**STATE SIGNIFICANT INFRASTRUCTURE  
ASSESSMENT:**

***North West Rail Link  
Windsor Road Bridge, Rouse Hill  
(SSI-5414 MOD 1)***

***Replacement of Approved Viaduct Crossing of Windsor Road  
and a Cable Stayed Bridge.***

Secretary's Environmental Assessment Report  
Section 115ZA of the  
*Environmental Planning and Assessment Act 1979*

**Figure 2: Proposed indicative site layout (Windsor Road Modification Report 2014)**

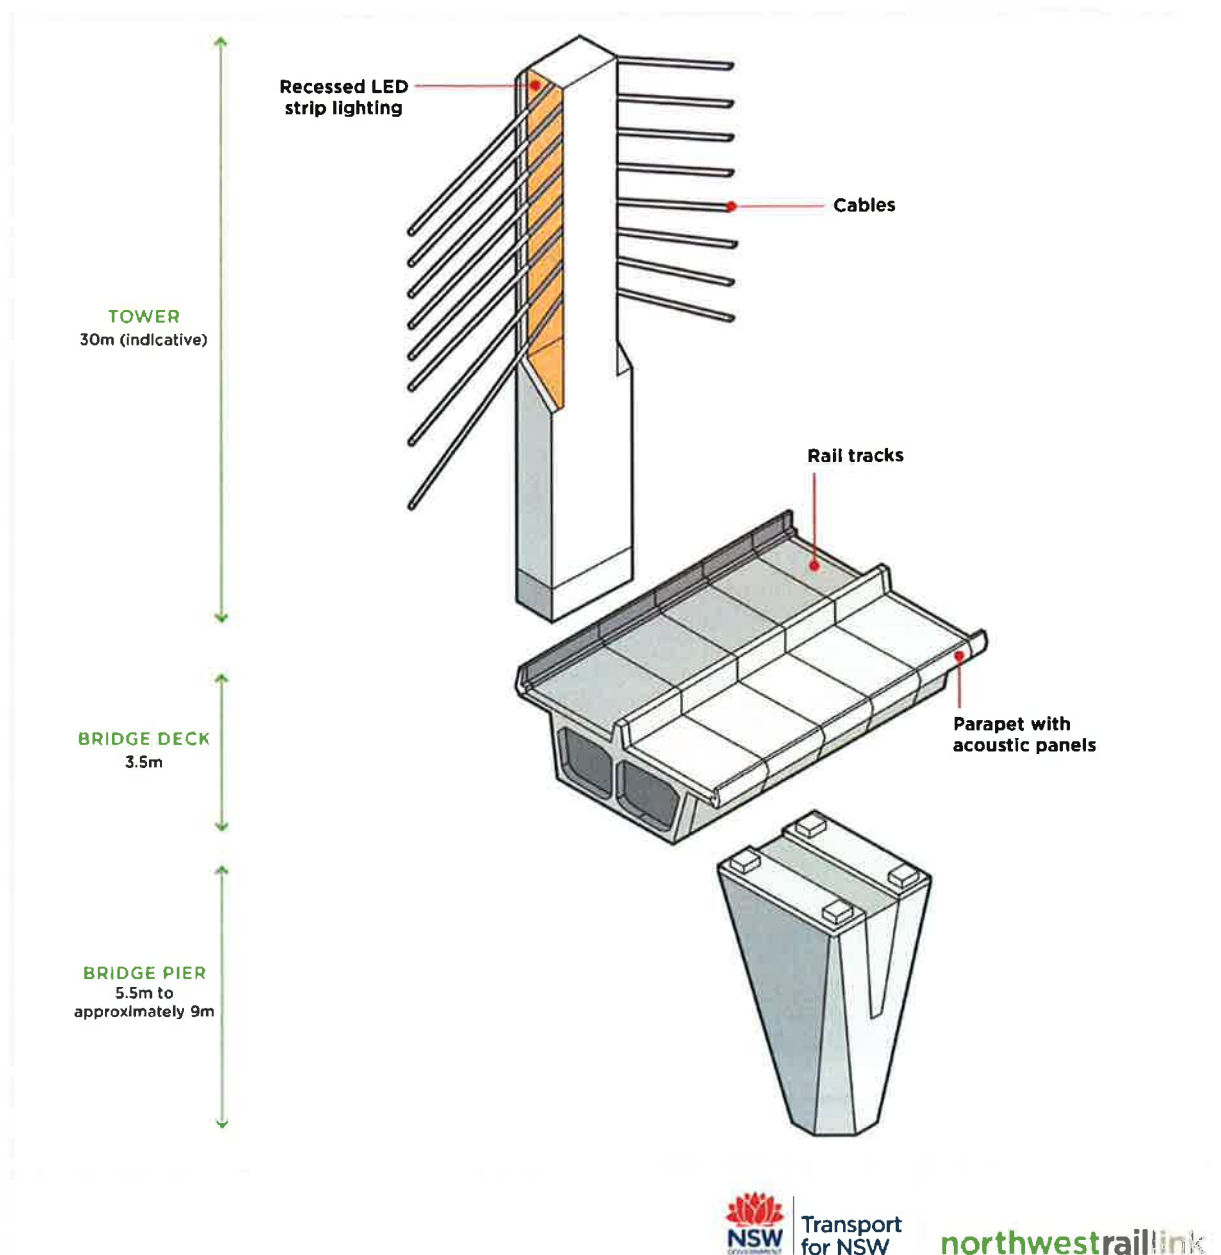
Transport for NSW (the Proponent) is seeking approval from the Minister for Planning to modify the Stage 2 – Stations, Rail Infrastructure and Systems (SSI - 5414) project approval to replace the section of the approved viaduct crossing Windsor Road with a 270m long cable stayed bridge. The approved viaduct, excluding the Windsor Road crossing, will remain as approved. The cable stayed bridge is supported by two towers approximately 45m in height. The bridge would be approximately 270 m long consisting of three main spans of 78m, 131m and 60m in length (Refer **Figure 2**). The structure will integrate with the viaduct at the elevated Rouse Hill Station. The towers and cables of the bridge will be subtly illuminated with the operation of light-emitting diode (LED) lighting.

The bridge deck would be a 15 m wide, 3.5 m deep dual carriageway to convey trains. The bridge piers would sit between the two carriageways. The eight cable stays will protrude from each direction of the towers to the bridge deck below. The design and construction of the bridge would meet Australian Standards (AS5100 – Bridge Design and where not specified AS1170 – Structural Design Actions) and will include a derailment kerb on the side of the rail and a deflection wall to protect the supporting cables from any potential derailment incidents (Refer **Figure 3**).
